GULF STATES UTILITIES COMPANY

River Bend Station-Unit 1
Docket No. 50-458

Enclosed is the Gulf States Utilities Company (GSU) response to Safety Evaluation Report (SER) Confirmatory Item #19 - Hydrogen Control (SER Section 6.2.5, Page 6-32/33.) Attachment 1 contains the GSU endorsements for various Hydrogen Control Owners Group (HCOG) submittals. These letters should be utilized to provide background and reference material for SER Confirmatory Item #19. Attachment 2 contains a revision to the Request for Additional Information (RAI) on the Hydrogen Ignition System (HIS) transmitted to W. J. Cahill (GSU) by A. Schwencer (Nuclear Regulatory Commission - NRC) on December 2, 1983 and supercedes the original GSU response from J. E. Booker (GSU) to H. R. Denton (NRC) dated December 30, 1983 (GSU Letter No. RBG-16679).

REQUEST FOR ADDITIONAL INFORMATION FOR USE IN THE EVALUATION OF
THE HYDROGEN IGNITION SYSTEM FOR THE RIVER BEND STATION, UNIT 1
MARK III CONTAINMENT

SIMPLIFIED ELECTRICAL SCHEMATIC

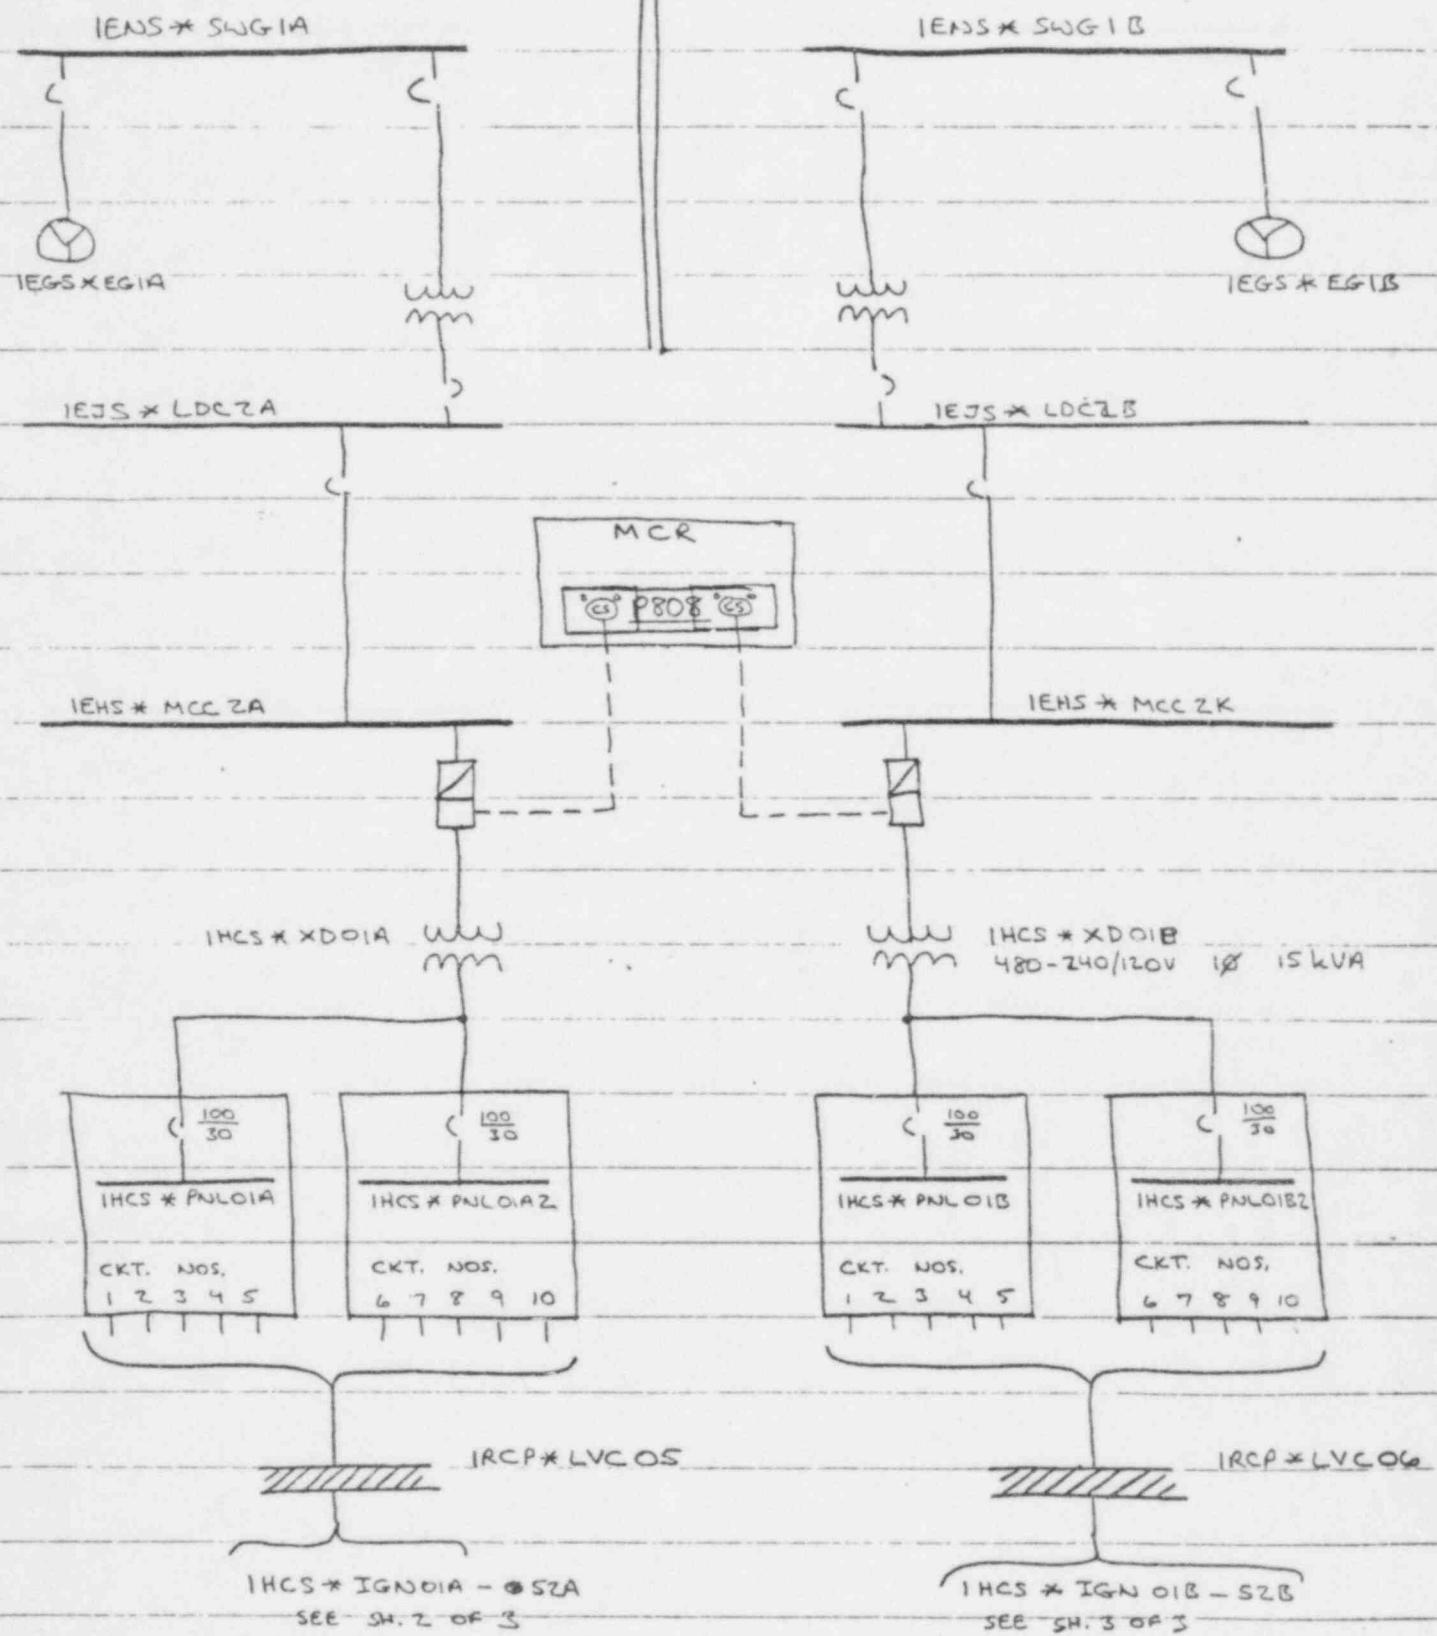
1. Provide a detailed description of the Hydrogen Ignition System (HIS) and its power supplies; include the total number of igniters, the numbers of circuit breakers, and a simplified electrical system schematic showing all the above stated items and any other major components.

The design of the Hydrogen Control System (HCS) is based on the concept of providing distributed ignition sources so that hydrogen combustion is accomplished in a controlled manner. The HCS consists of a total of 104 igniters, powered by two physically separate and electrically independent divisions each containing 52 igniters. Division I is powered from motor control center 1EHS*MCC2A and Division II is powered from motor control center 1EHS*MCC2K. A simplified electrical schematic showing the HCS power distribution and associated circuit breakers is provided in TAB I. The HCS power distribution for the HCS includes combination starters with remote control switches for each electrical division in the main control room. The main transformers for each division are 15 KVa, 480 Volt to 120 Volt transformers. The main distribution panels are 120 Volt with five molded case circuit breakers utilized in each panel.

The control circuits for the igniters are provided in TAB II

EE-460 U-5, V-5, W-5, X-5, AC-4, AD-3,
AE-3, AF-4, AJ-2, AK-3, AX-2

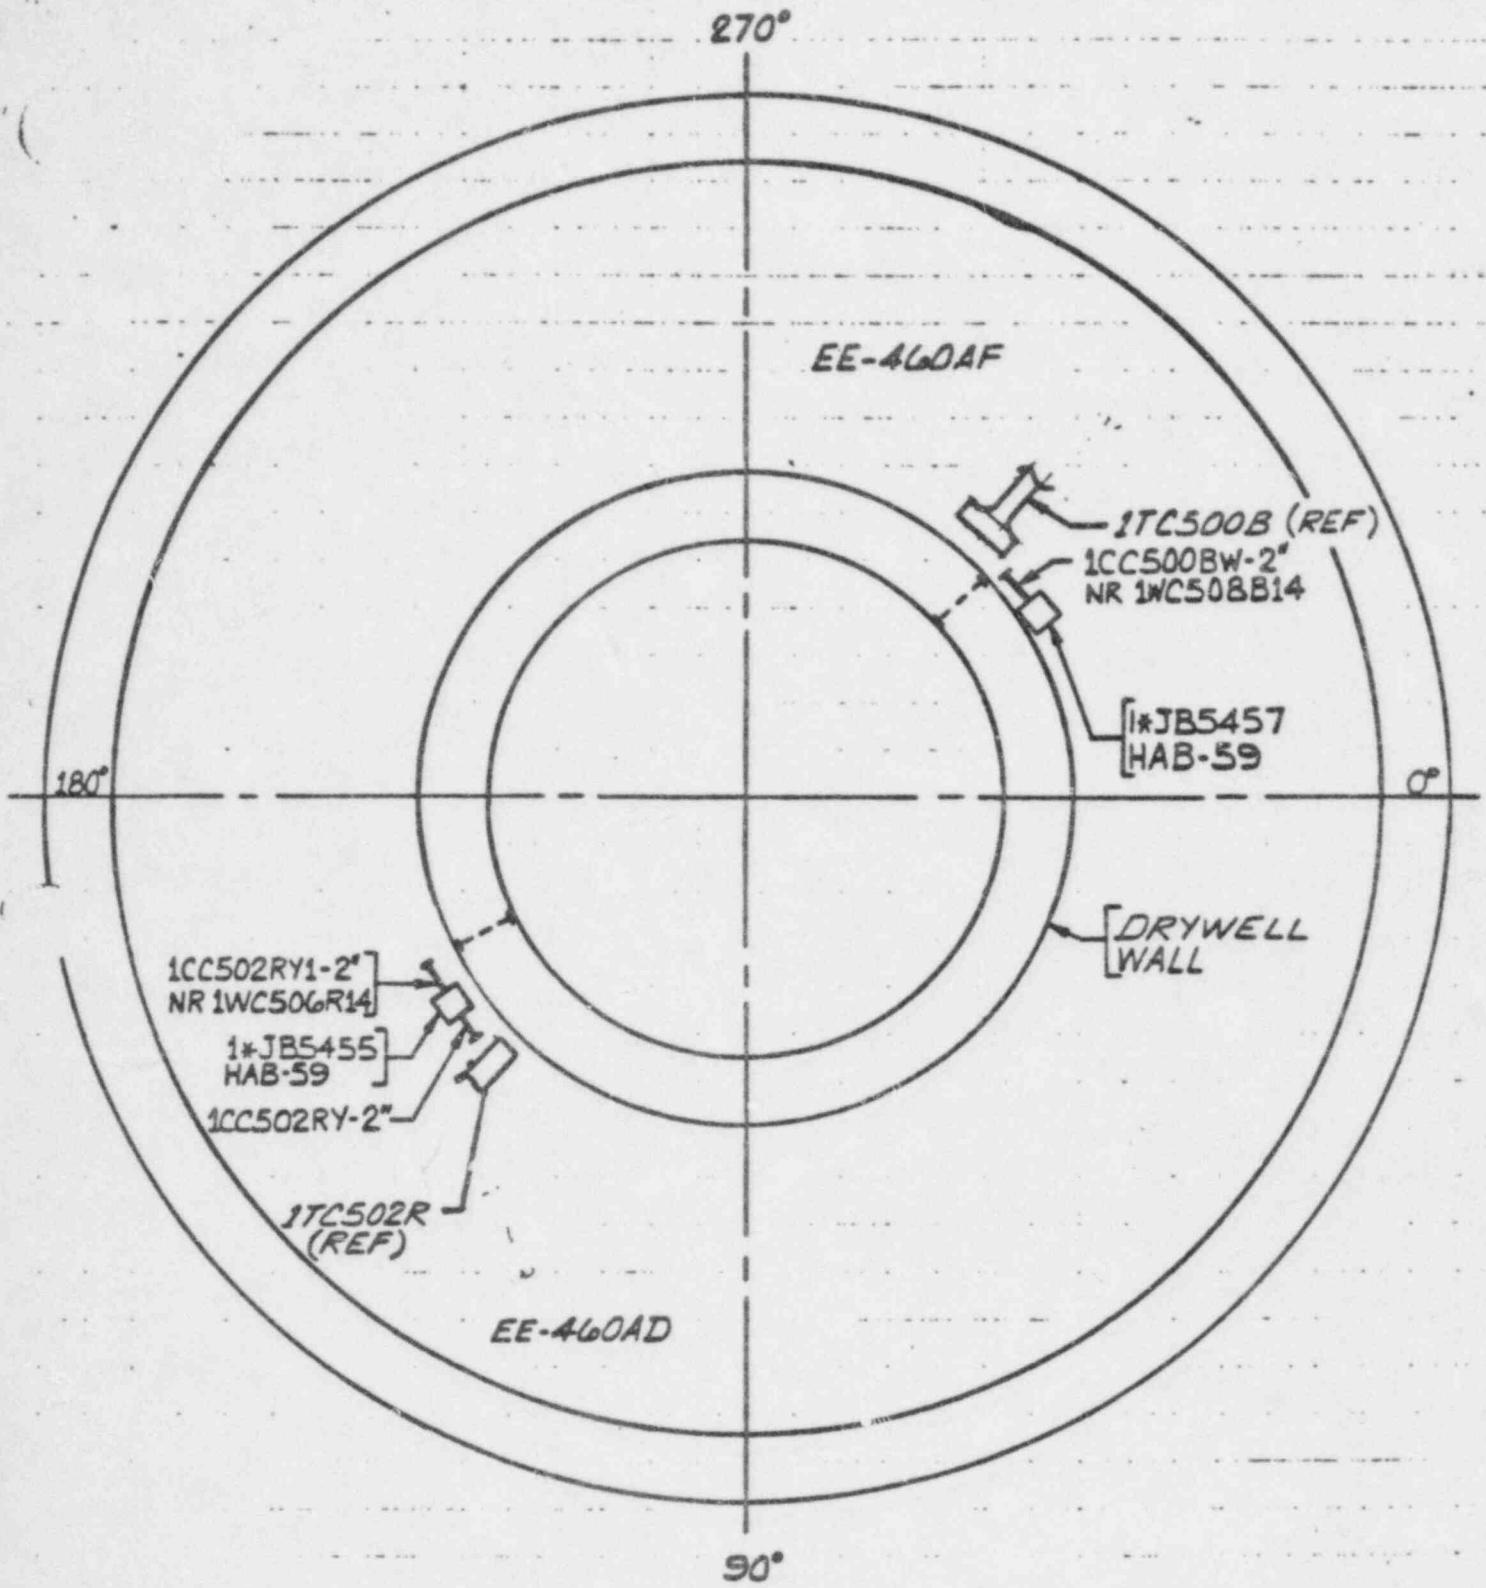
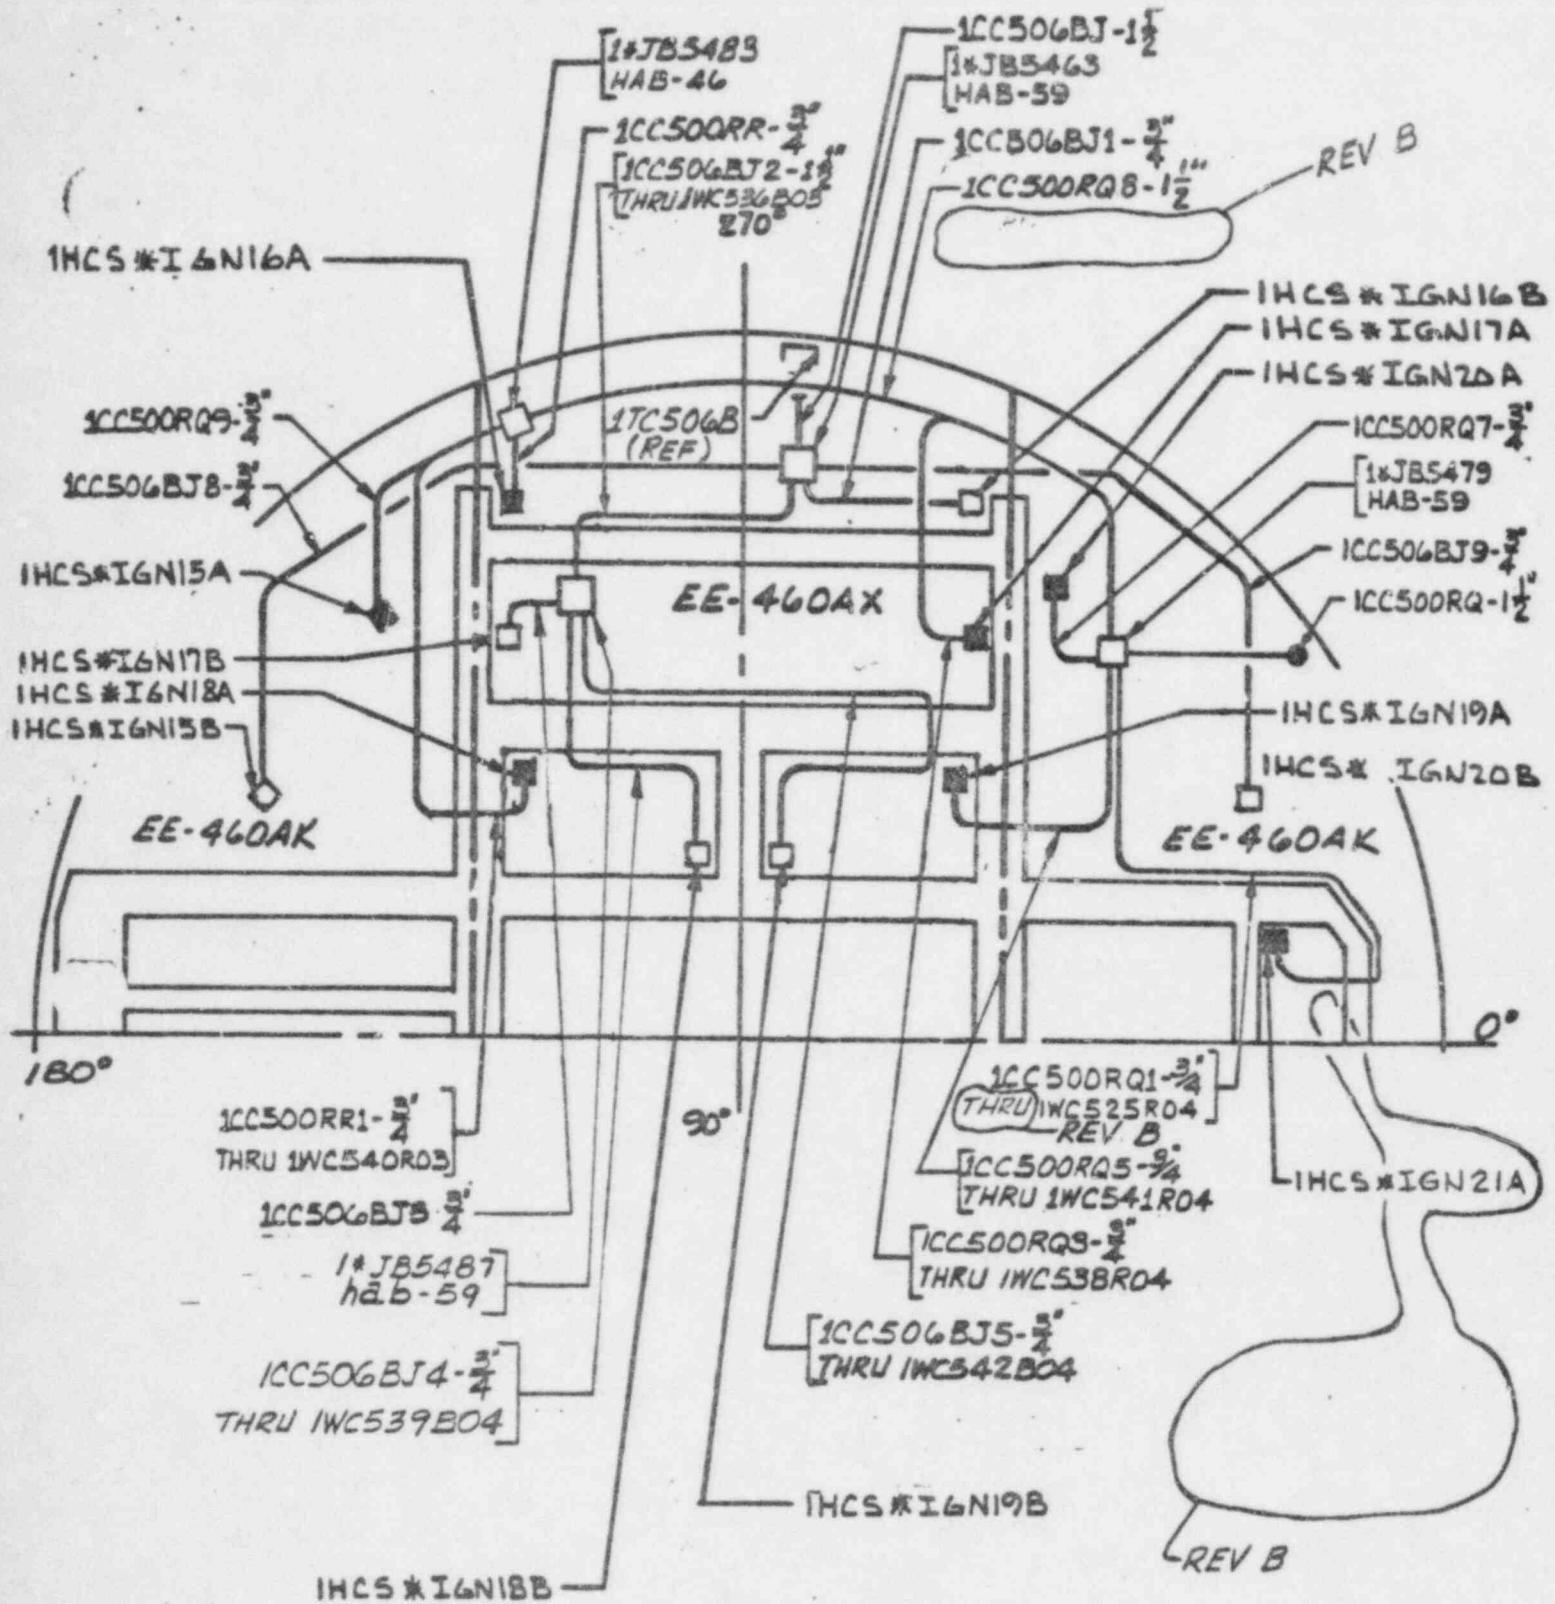
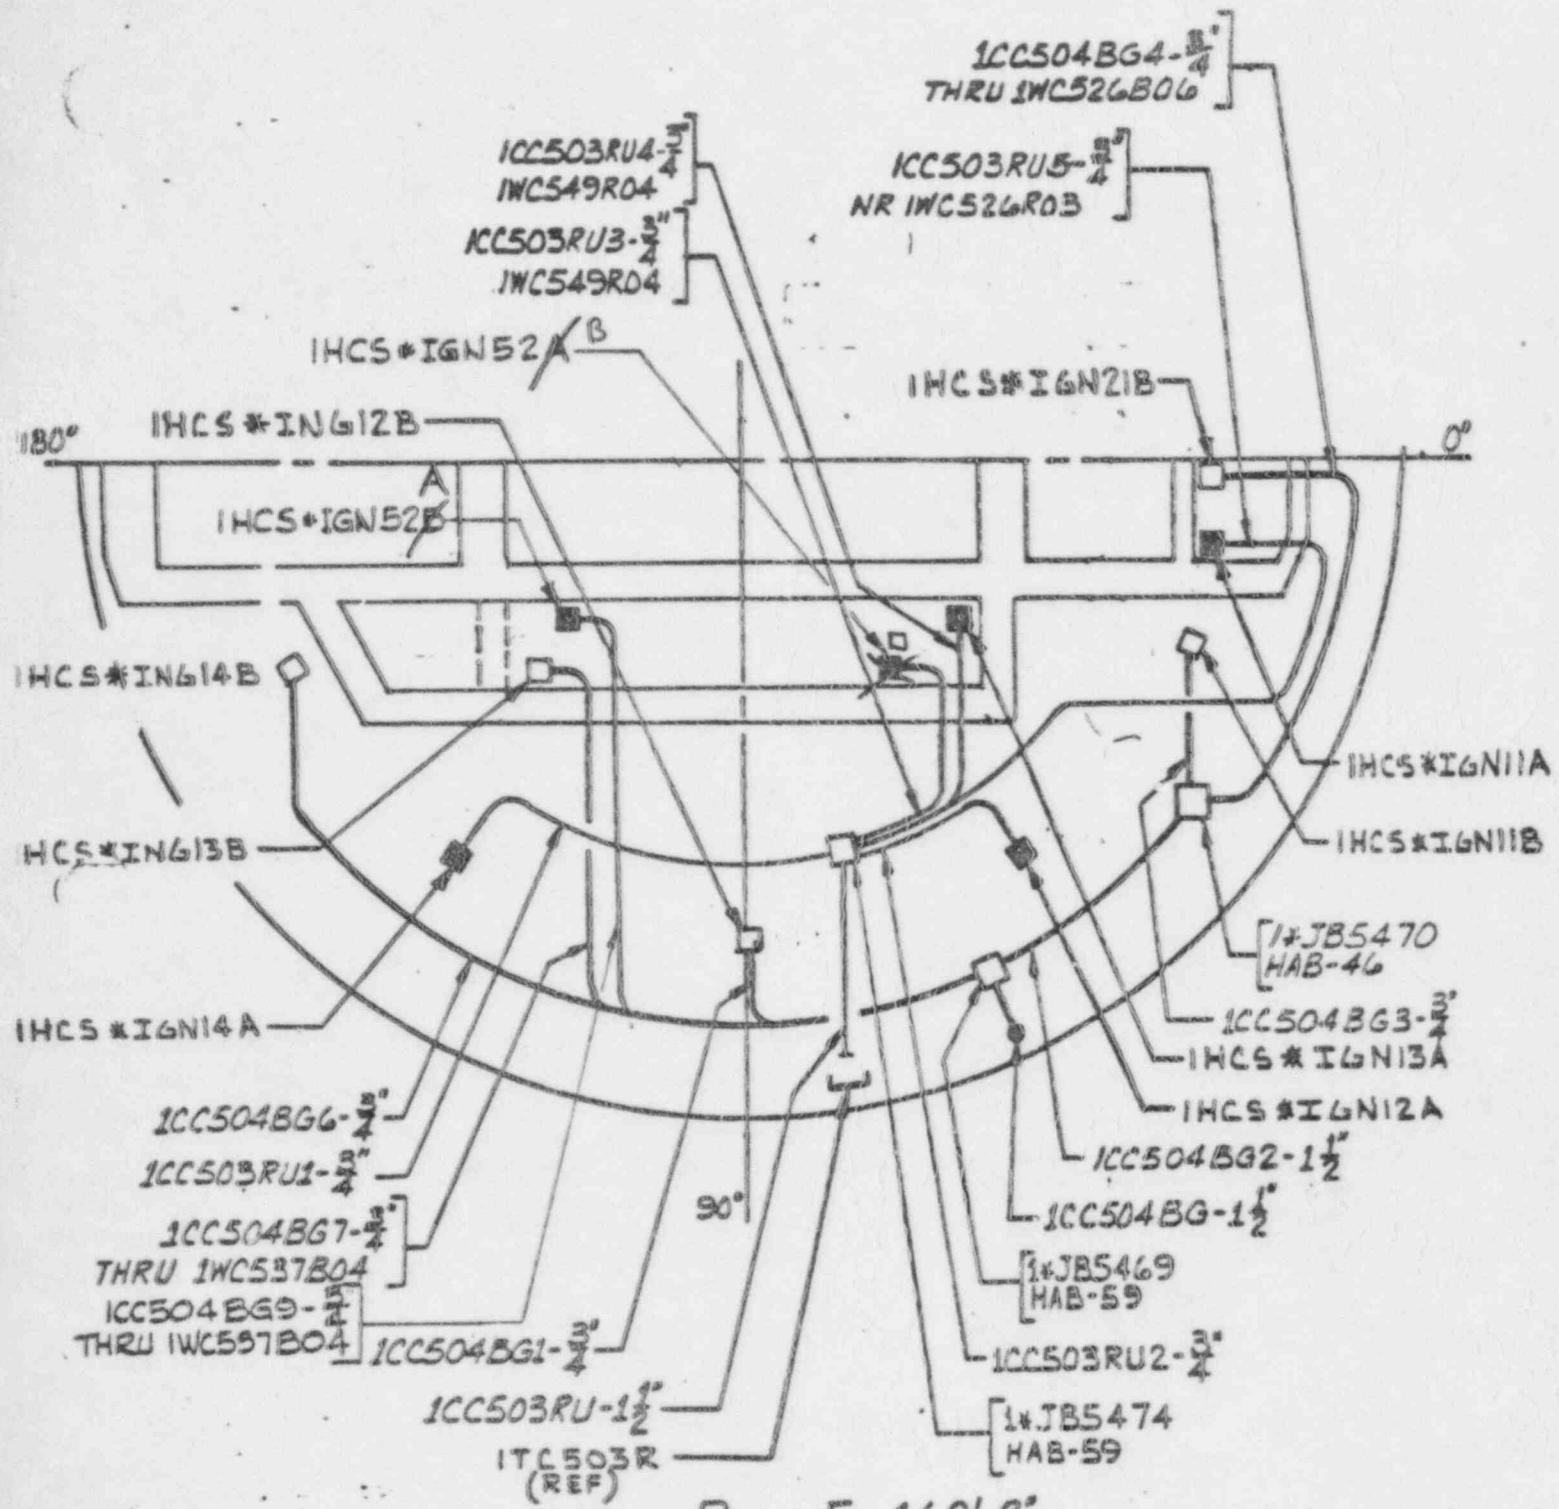
16 DWGS EE-46OU, V, W, X, AC, AD, AE, AF, AJ, AK & AX ARE REVISED ADDING CONDUITS, JUNCTION BOXES, AND LOCATING HYDROGEN IGNITERS AS SHOWN ON PAGES 3 THRU 14.
